115 Winthrop Square Supplemental Information

Submitted to:
BOSTON PLANNING & DEVELOPMENT AGENCY
One City Hall, Ninth Floor
Boston, MA 02201

May 4, 2018

The Boston Redevelopment Authority (“BRA”) d/b/a The Boston Planning & Development Agency (“BPDA”) is issuing this Supplemental Information Request (“SIR”) in response to and based on the review of a Draft Project Impact Report (“DPIR”) for the 115 Winthrop Square project (the “Proposed Project”), which MCAF Winthrop, LLC (the “Proponent”) submitted to the BPDA on January 2, 2018. Notice of the receipt by the BPDA of the DPIR was published in the [Boston Herald](#) on January 2, 2018, which initiated a public comment period with a closing date of March 19, 2018. Comments received since then have subsequently been added as well.

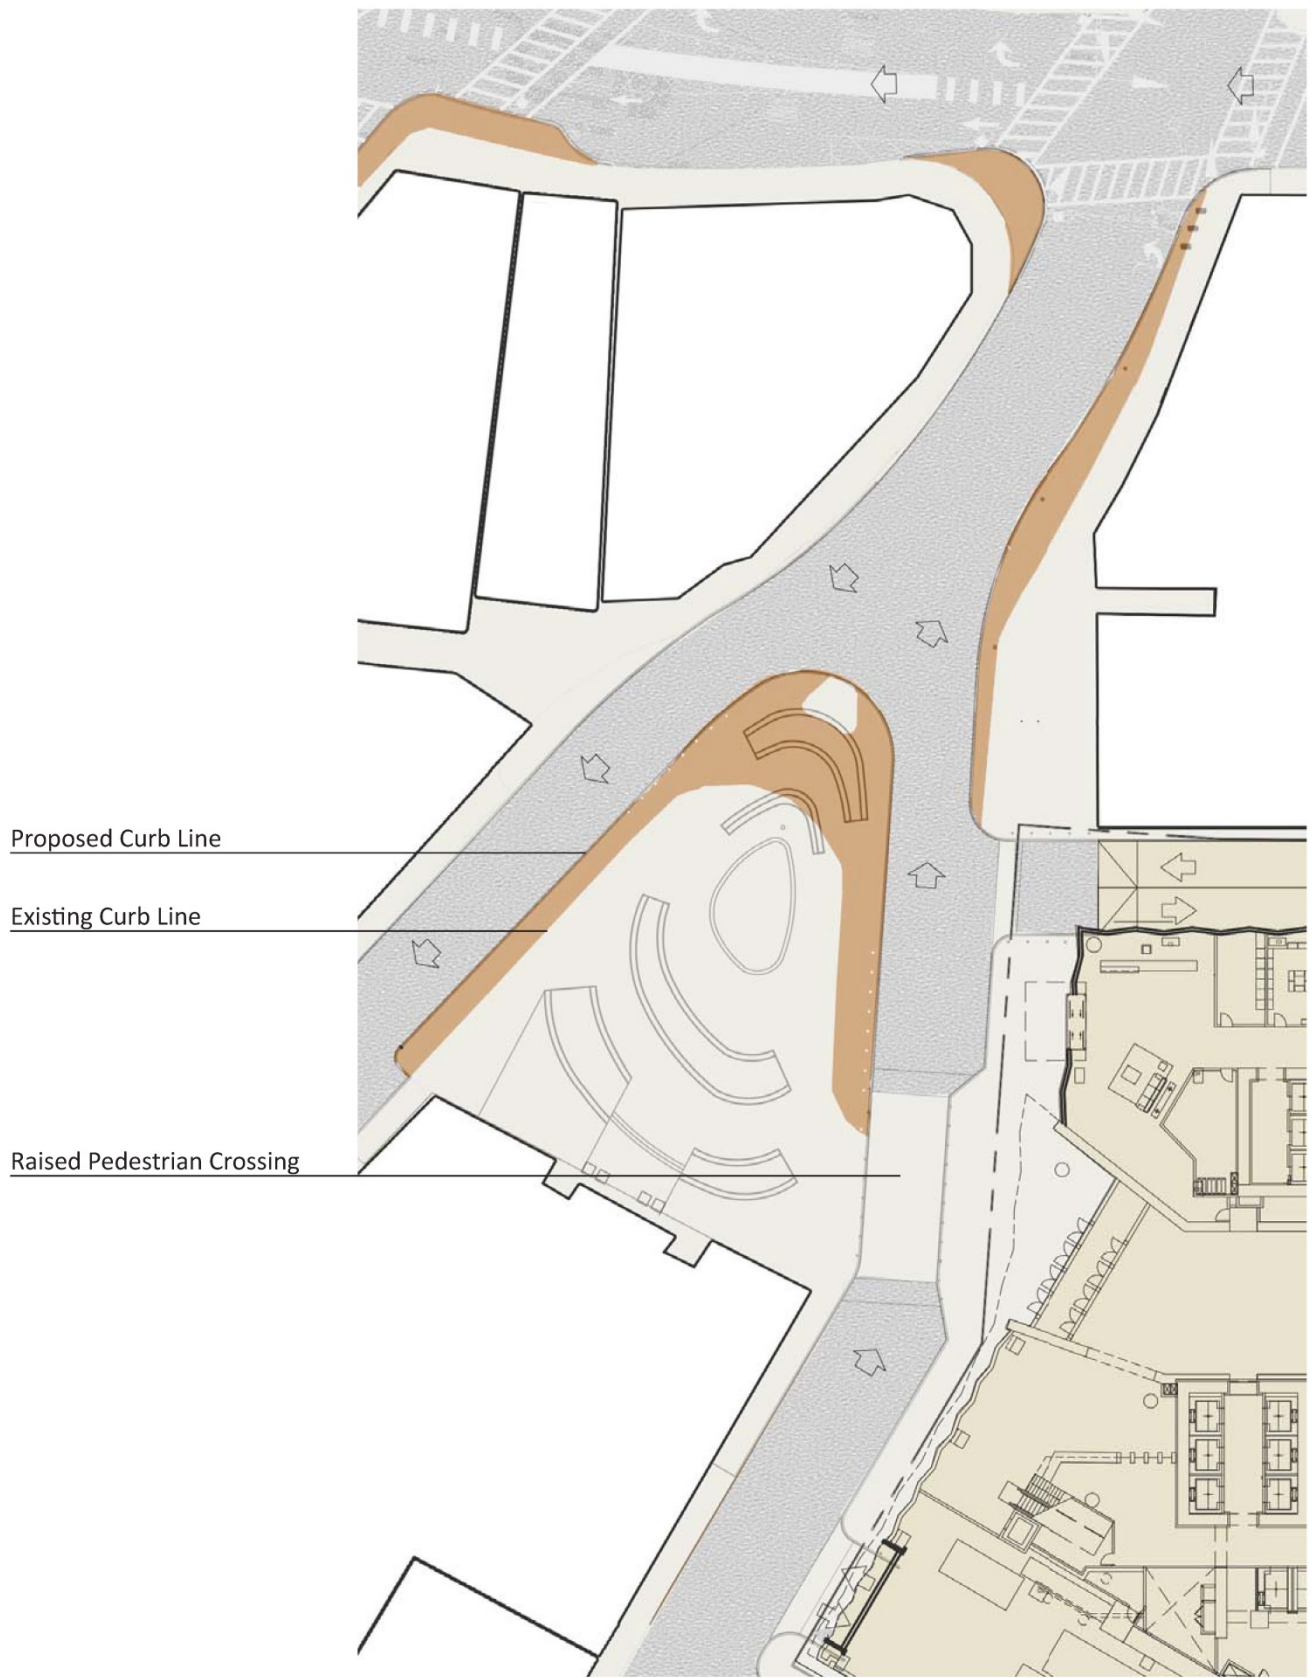
- More detail on tabling plans and the expanded sidewalk. BPDA 03
- Water feature proposal should be for all seasons. BPDA 04
- Tree removal and new landscape are proposed due to age of existing trees and height of soil that has developed over time - need a closer look at grading and tree replacement strategy. BPDA 05

The Winthrop Square design will include an activated center creating a visual interest throughout the day and throughout the year. From this center, the design undulates outwards, finding form in the Square's hard and softscaped elements. The ground plane emerges at varying levels to frame planting beds and create ample seating. Lighting will be used to highlight the walls and paths. These nestled linear elements create an elegant and contemplative atmosphere that can be enjoyed by individuals or groups of people. Flowering understory trees frame the central plaza while large canopy trees provide an edge. Ripples will be repeated within the planting beds through the color and height of the groundcover (Figure 2-1 Draft Landscape Plan).

Figure 4-1
115 Winthrop Square Project Rendering

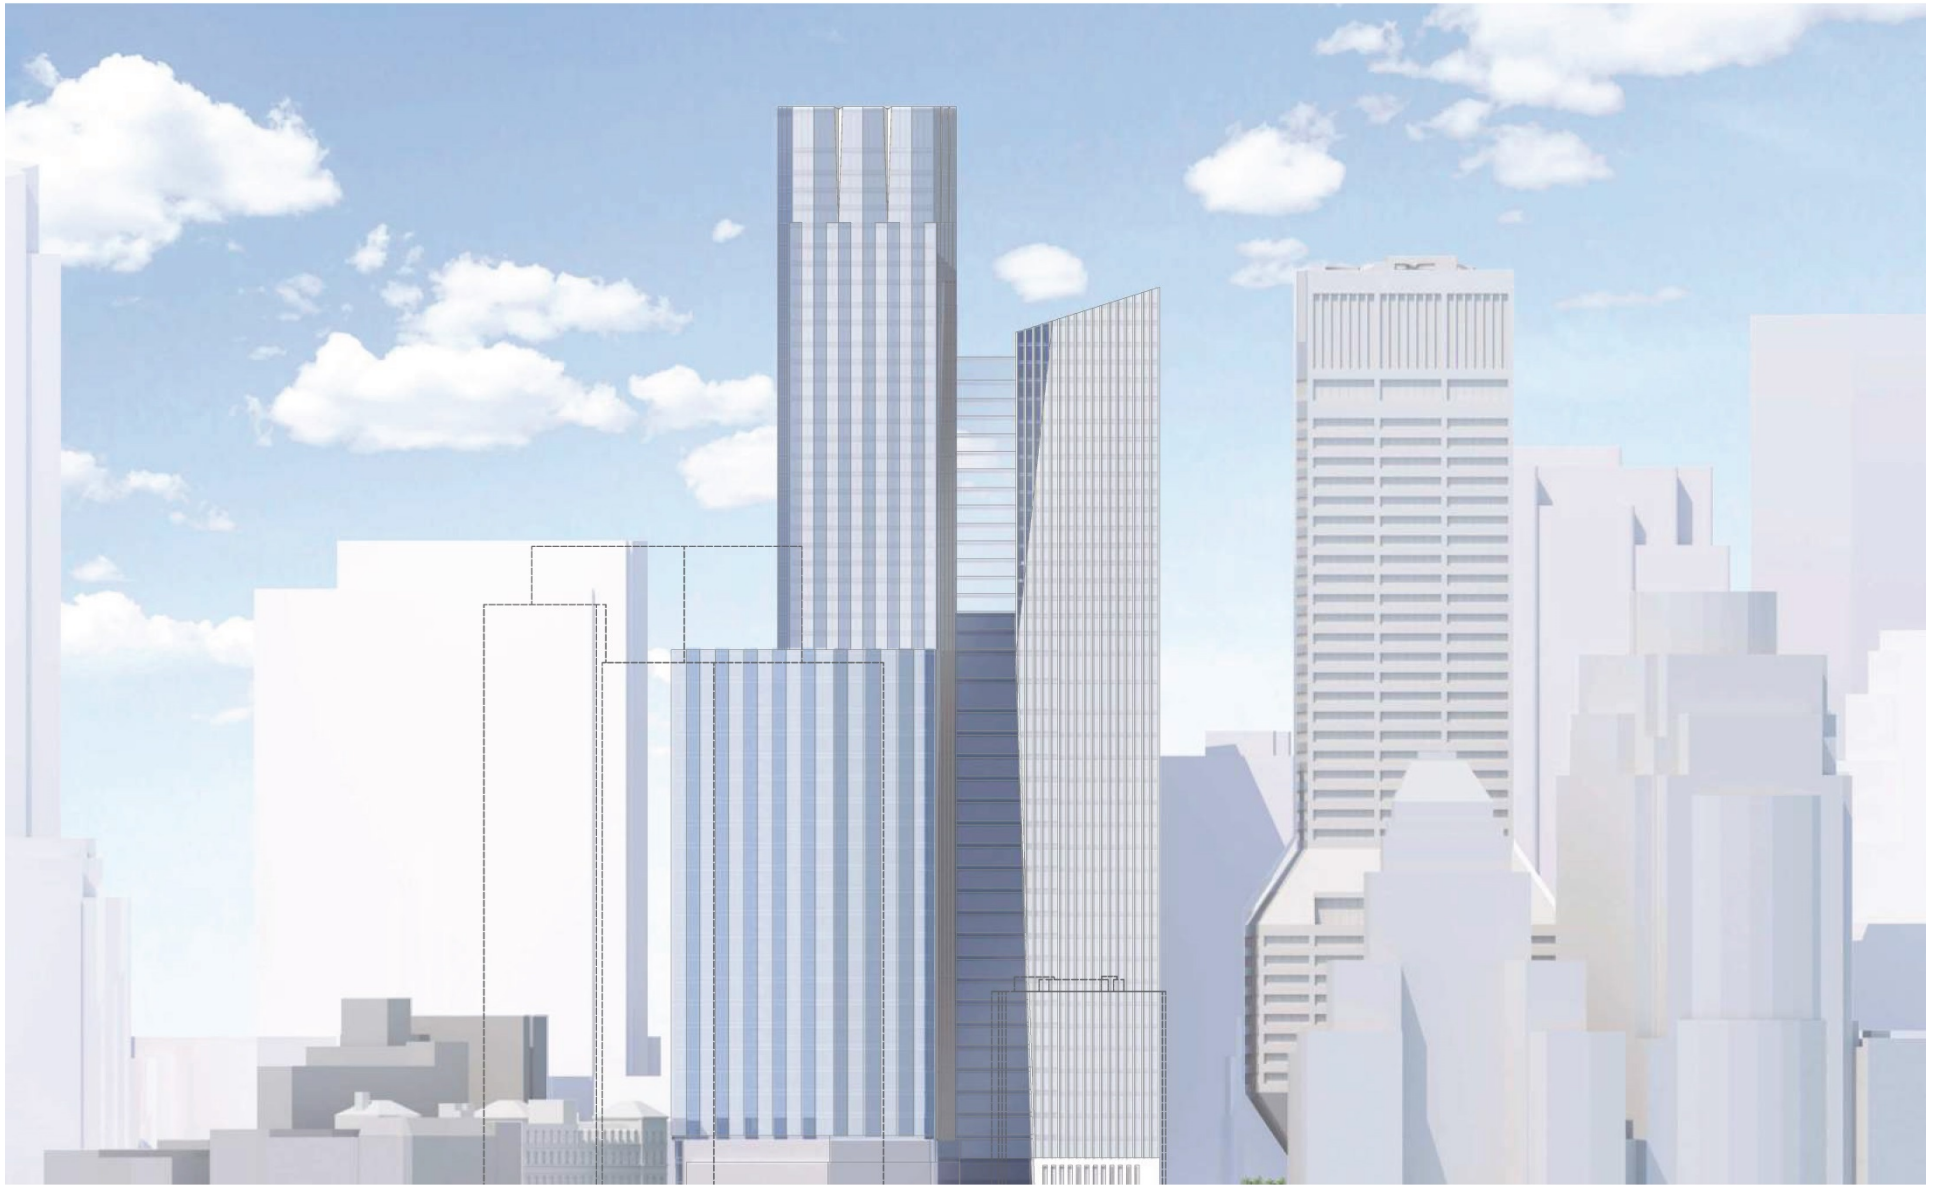
- Present massing and design evolution from the PNF, to the DPIR, and BPDA 22 onwards.
- The proponent returning to the simple, strong vertical detail, is a welcome development. Further design details should be forthcoming for the key BPDA 23 elements of the building and facade.

Design updates include lowering the east portion of building by several floors and redesigning the building to read as two towers linked together on each upper floor by a narrow skybridge. Figure 4-1 is a rendering and 4-2 is an elevation of the 115 Winthrop Square Project. This 'two-tower' design was further enhanced by shaping the building, allowing the two sides of the building to read as siblings rather than as a heavy single tower. At the main portion of the resulting west tower of the Project, the pleated façade is articulated at the sky plane, and represents the tallest portion of the building. The resultant "crown" breaks down the pleated façade, splitting them, and creating reveals as the building reaches the sky. The Federal Street portion (east tower) of the building provides an opportunity for a more dramatic sky-line expression such as the canted plane, and steps down from the main tower to better differentiate the building forms.

Figure 4-2
Elevation of 115 Winthrop Square Project

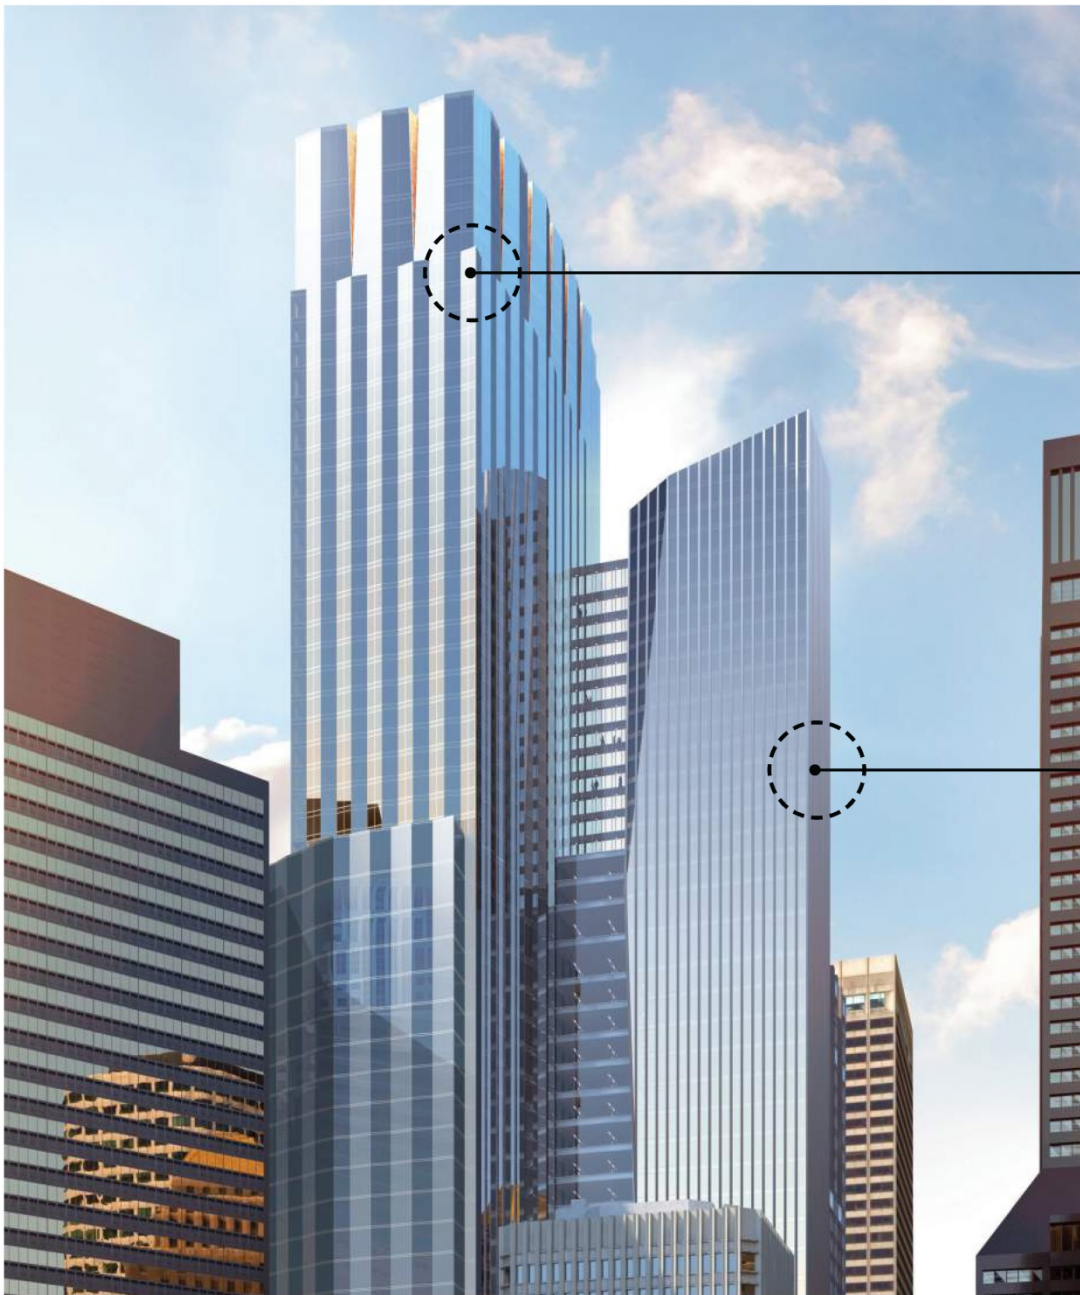
- Provide more detailed elevations and skyline views, including from Dewey BPDA 26 Square, the Greenway, and Interstate 93 northbound.
- As noted above, the Great Hall entries on both Devonshire and Federal BPDA 27 Streets need further study.
- Maximize the appearance and animation of 'Public' vs. 'private' frontage BPDA 28 along Devonshire Street.
- Develop initial thoughts on the design, scale, lighting, and material treatment BPDA 29 (including the potential of doors) of the parking entries, and the residential lobby adjacent to the entry off Devonshire Street.

Figure 5-1
Curbside Uses

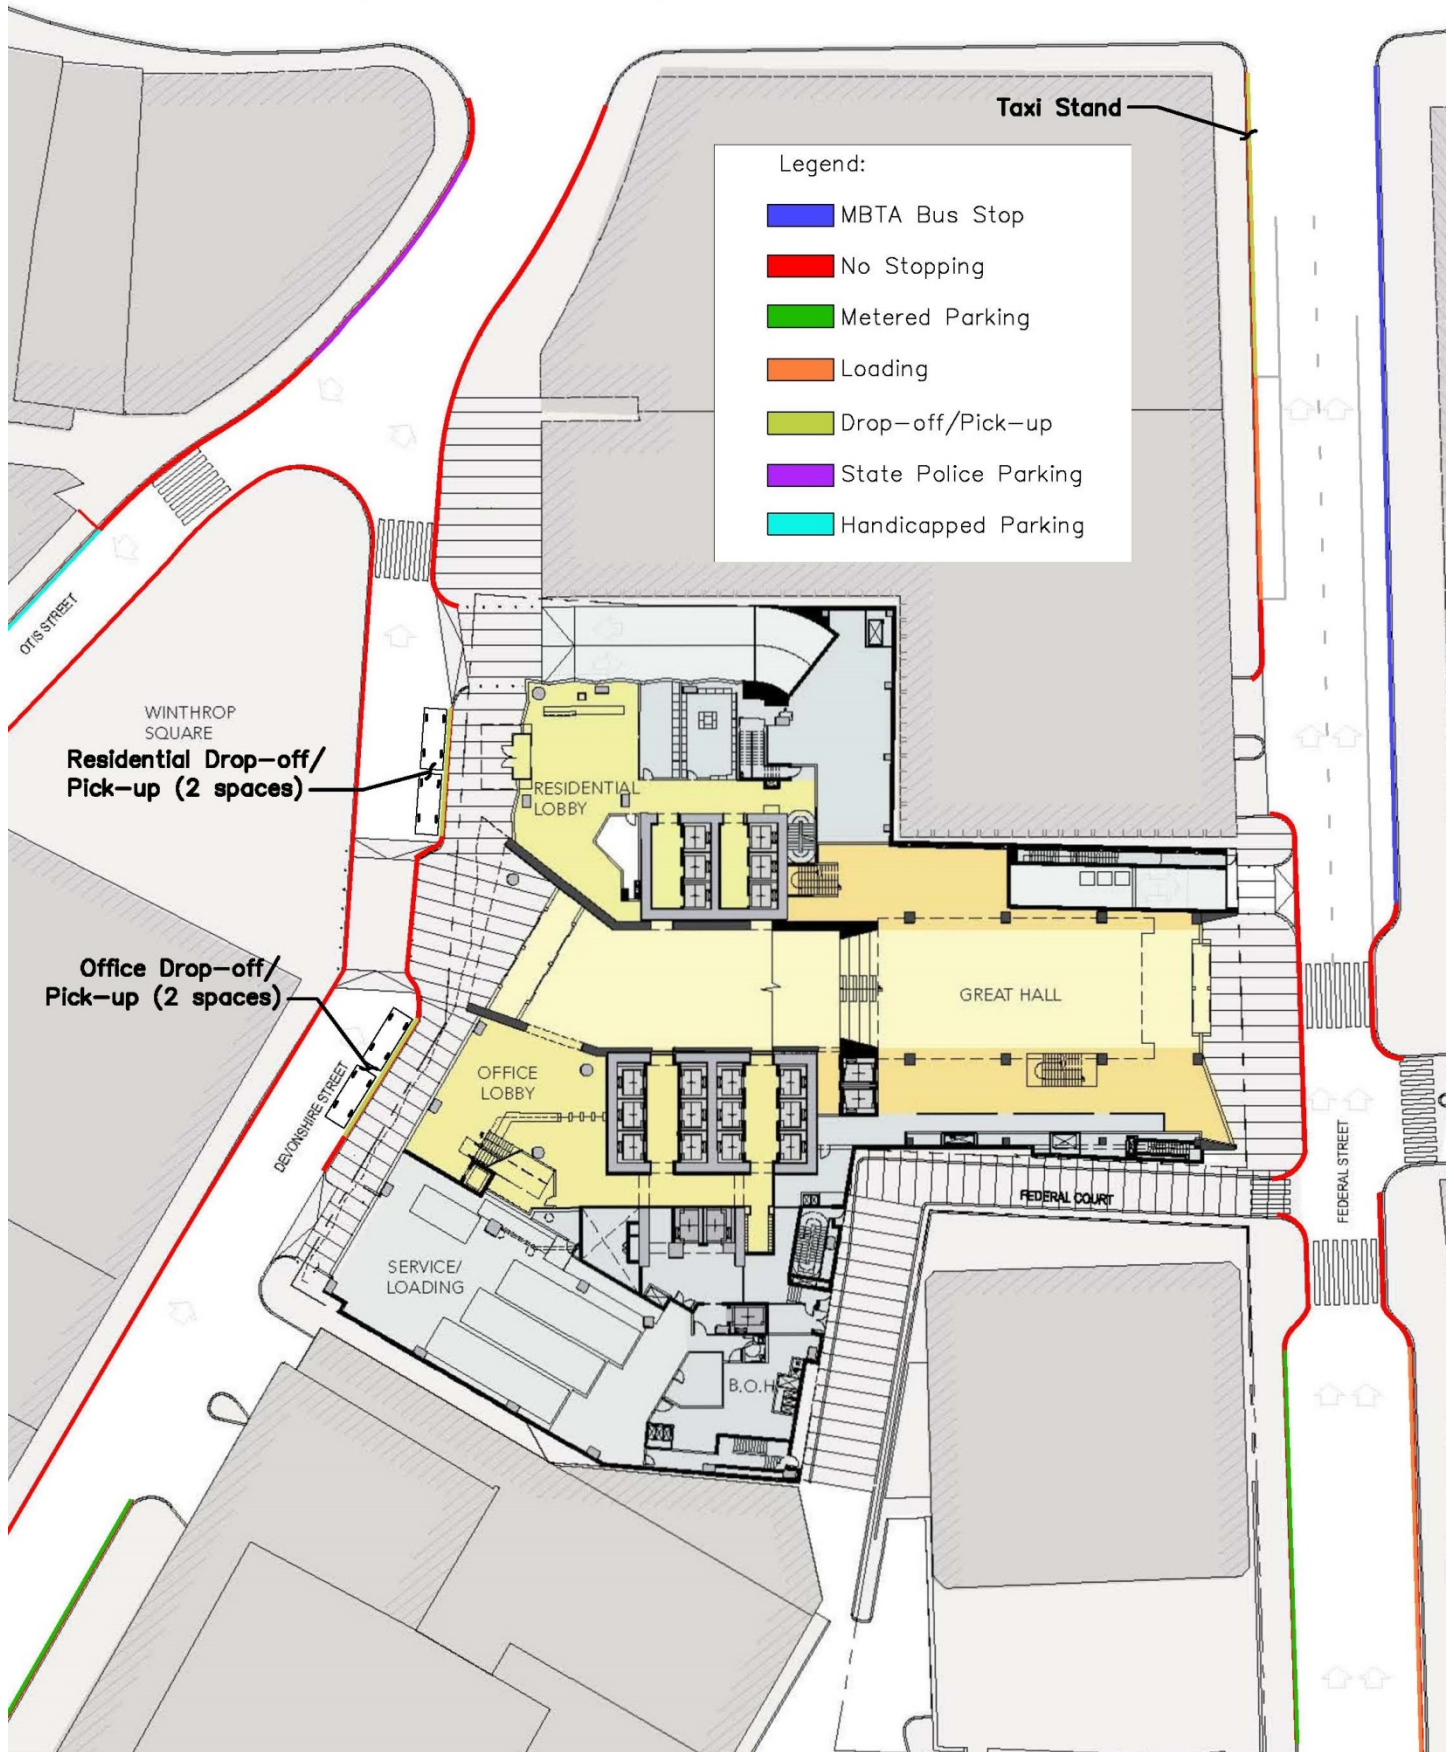
BPDA 01 Clarify curb use overall, on both Devonshire and Federal Streets.

Existing curb use regulation in the study area were presented in Figure 4-5 in the Draft PIR. Proposed curb uses in the vicinity of the Project are shown on Figure 5-1.

Along the Project's Devonshire Street frontage, two drop-off/pick-up spaces are located in front of the office lobby, and two drop-off/pick-up spaces are located in front of the residential lobby, just south of the residential driveway. The primary residential drop-off/pick-up is located off-street in the first below-grade parking level. The three existing State Police spaces on the Winthrop Square island will be re-located permanently under the demolition phase of the Construction Management Plan, and these spaces will not be returned to this location when the Project is complete. On the Otis Street side of Winthrop Square, the design of the public realm seeks to optimize the pedestrian accommodations and minimize impact to the existing curb uses.

On Federal Street, the curb in front of the Great Hall is being expanded on both sides of Federal Street to reduce the pedestrian crossing distance while still allowing for two lanes of through traffic. Figure 5-1 shows a reduction of approximately 35 linear feet in the existing MBTA layover/staging curbside now given to pedestrian space.

Figure 3 – DGP based on existing conditions at model office location in Fig. 2.

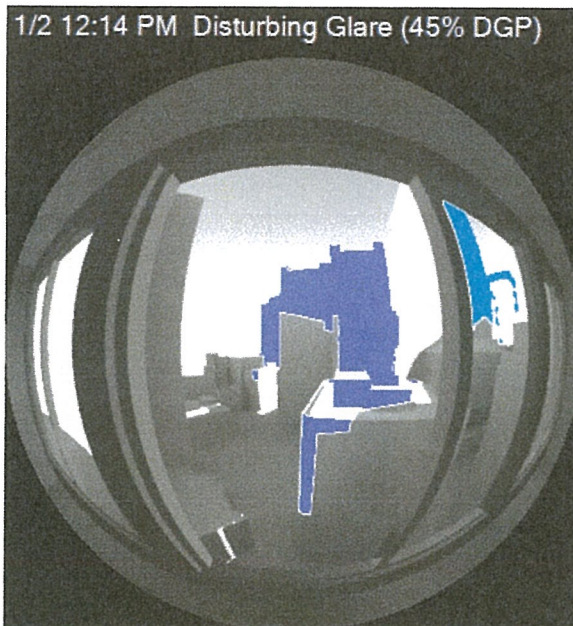
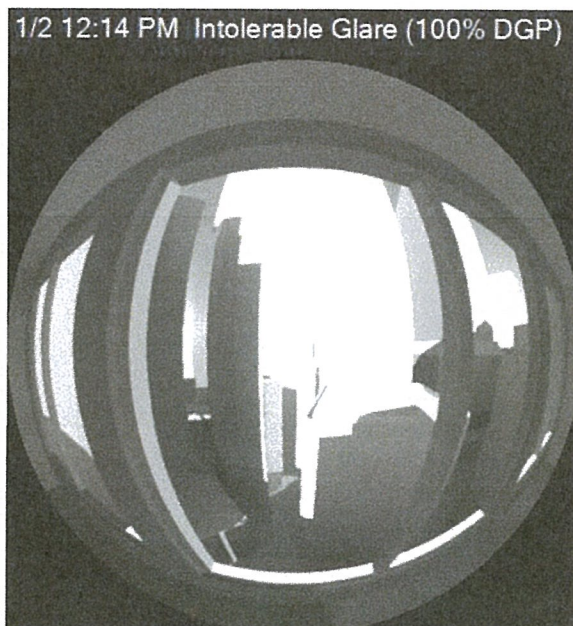
SGH 02 Our results (Figs. 3 and 4) show that when Winthrop Square Tower is added to the view, DGP increases from disturbing to intolerable. This result is specific to one upper and less obstructed location (point of view) and at one point in time. RWDI also studied two lower and more obstructed locations, Receptor Points F30 and F31, however, it is important to note this glare condition is not isolated to these three locations and would likely cover a large portion of the north elevation. Further study is needed to show the path of reflections over the day across the north elevation and to understand the extents of intolerable glare conditions.
